ZEN Design Consultants, Inc.
6 OLD NORTH PLANK ROAD, SUITE #103
NEWBURGH, NEW YORK 12550
(845) 568-0366 (phone)
13-002-BCI

Re: Gibson Subdivision
4 Lot Residential Subdivision
122 Rock Cut Road
Section 47 Block 1 Lot 28.2
Town Project : 13-09

Comments addressed from BC Planning, LLC (dated: 07/18/13):

WILLIAM J. MOREAU, P.E. ENGINEER	GIBSON ESTATES		
	4 LOT SUBDIVISION		
SITE PLAN			
ROCK CUT ROAD, SBL: 47-1-28.2			
TOWN OF NEWBURGH, ORANGE COUNTY, NY			
DATE	SCALE	JOB NUMBER	SHEET NUMBER
03/28/2013	1"=30'	13-002-BEC	2 OF 4

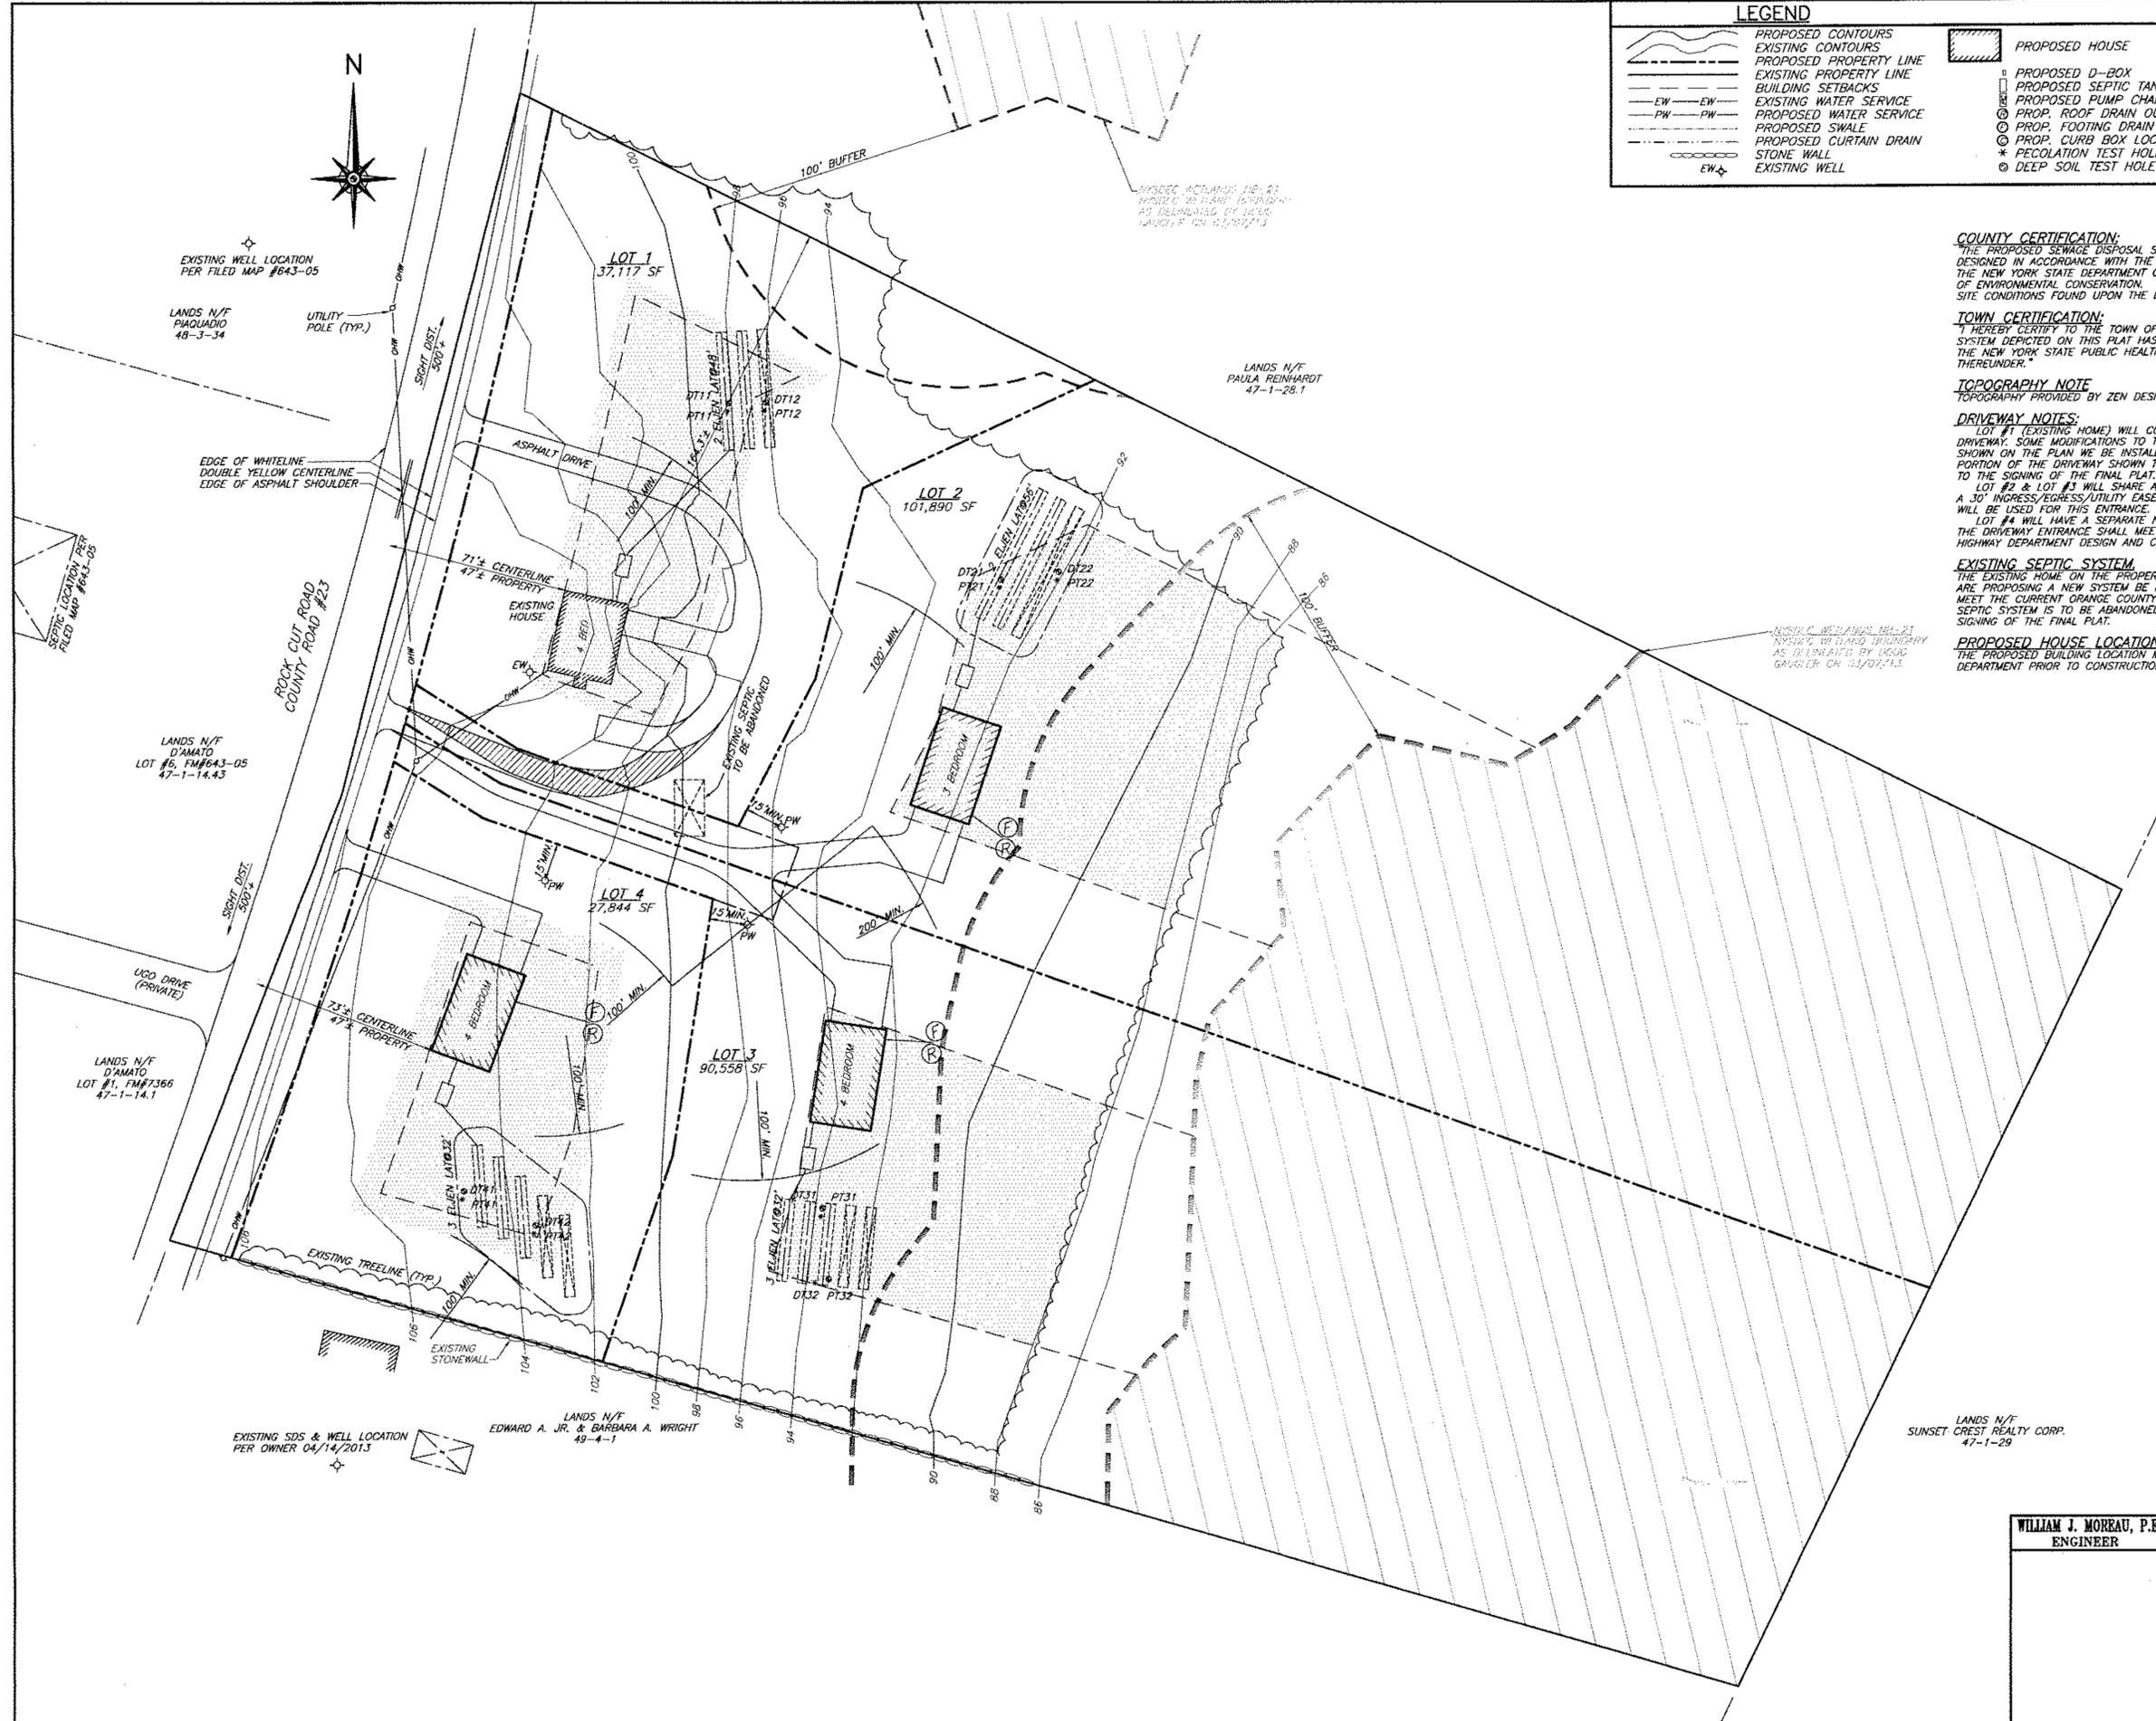
1. Proposed house location note on Sheet 2 of 4 should read that survey plans will be submitted to the Building Department prior to construction of foundations.
This note has been adjusted.
2. If shaded areas within building envelope is to depict a buildable areas, outside of NYSDEC regulated areas should be incorporated. Areas within the regulated wetland are not considered buildable.
The shaded areas have been adjusted and the associated buildable area re-calculated.
3. Reference to septic system notes still contained Orange County Health Department references. Health Department review of this has not been undertaken.
The references have been removed.
4. Construction of a new subsurface sanitary sewer disposal system to serve proposed Lot 1 is required prior to stamping of the plans.
This is understood.
5. Orange County DPW approval for access drives is required.
This is understood.

GIBSON ESTATES
4 LOT SUBDIVISION
OVERALL LAYOUT
 ROCK CUT ROAD, SBL: 47-1-28.2
 TOWN OF NEWBURGH, ORANGE COUNTY, NY

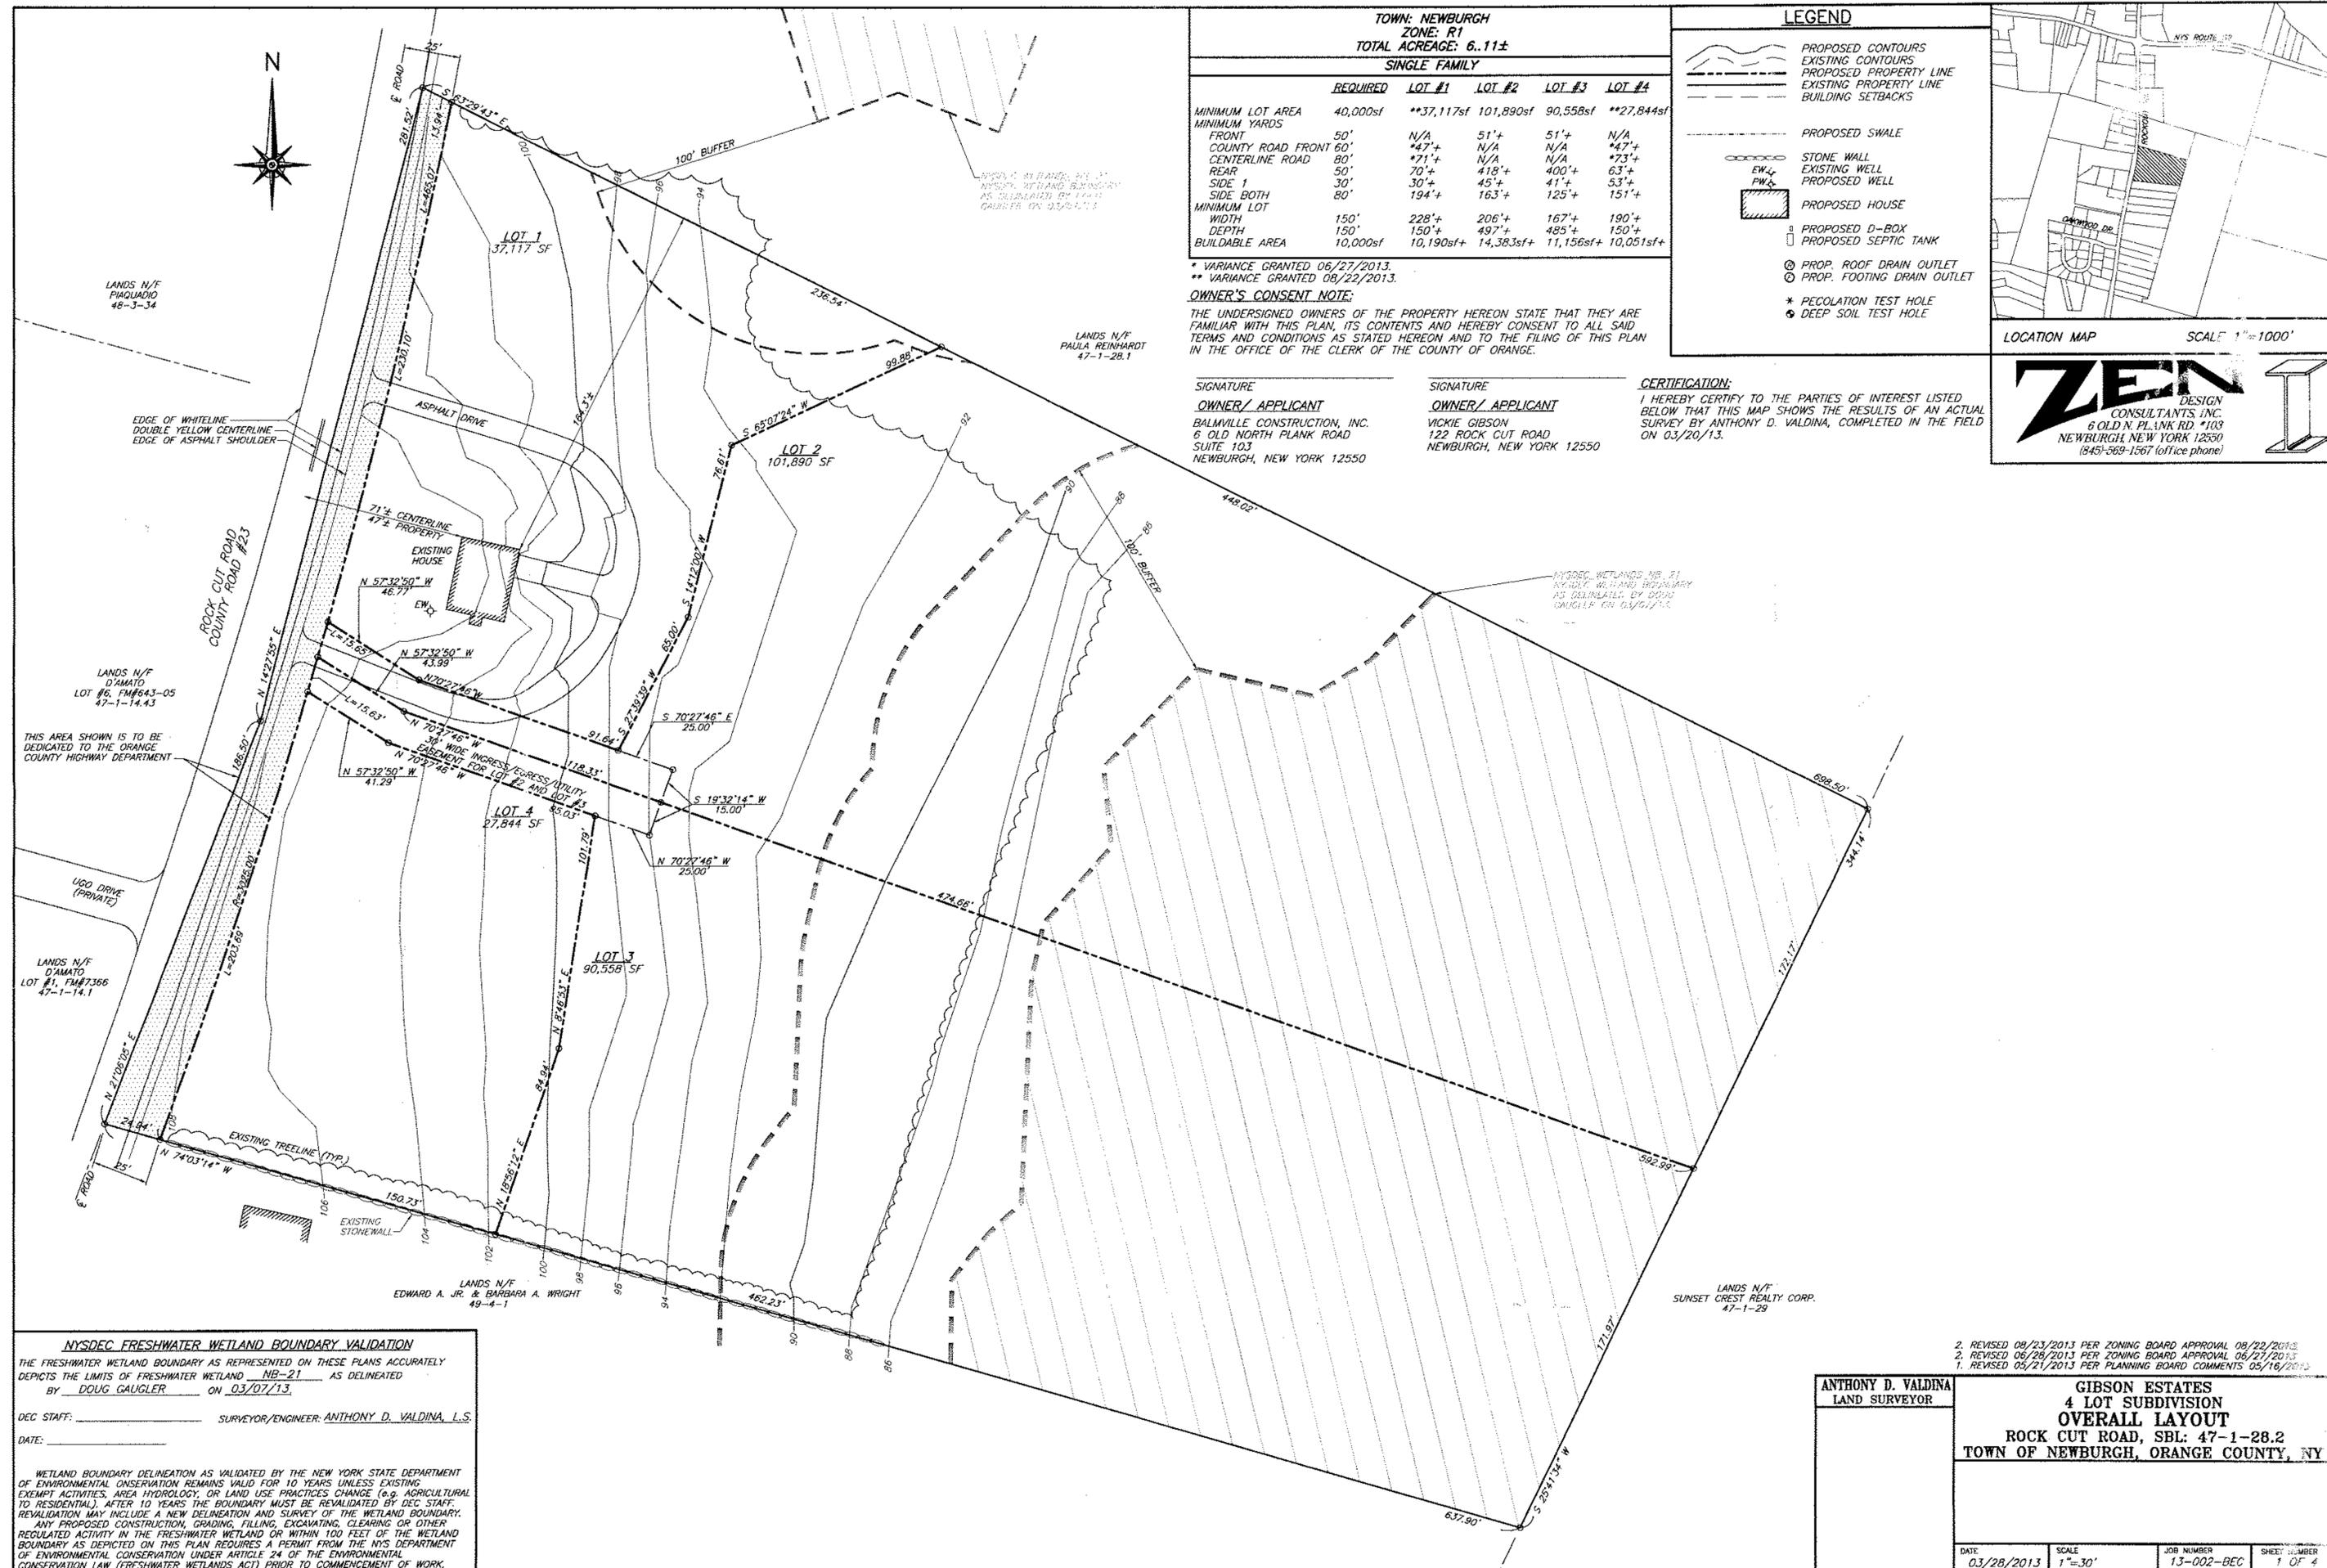
2. The lot line configuration previously showed two strips of approximately 15 feet along the northern and southern property lines to make the necessary square footage for the front lots. The layout now shows a one foot line with a triangle piece of property belonging to the front lots in the back yard of the back lots. I do not believe this configuration will work, as it is bound to cause disputes by the neighbors. The applicant should look to somehow rework the property lines to a more agreeable layout.
We went to the ZBA on 08/22/2013, received the needed variances to have this small strip of property along the northern and southern property lines removed and have noted the zoning variances approved on the plans and the date of the approval.
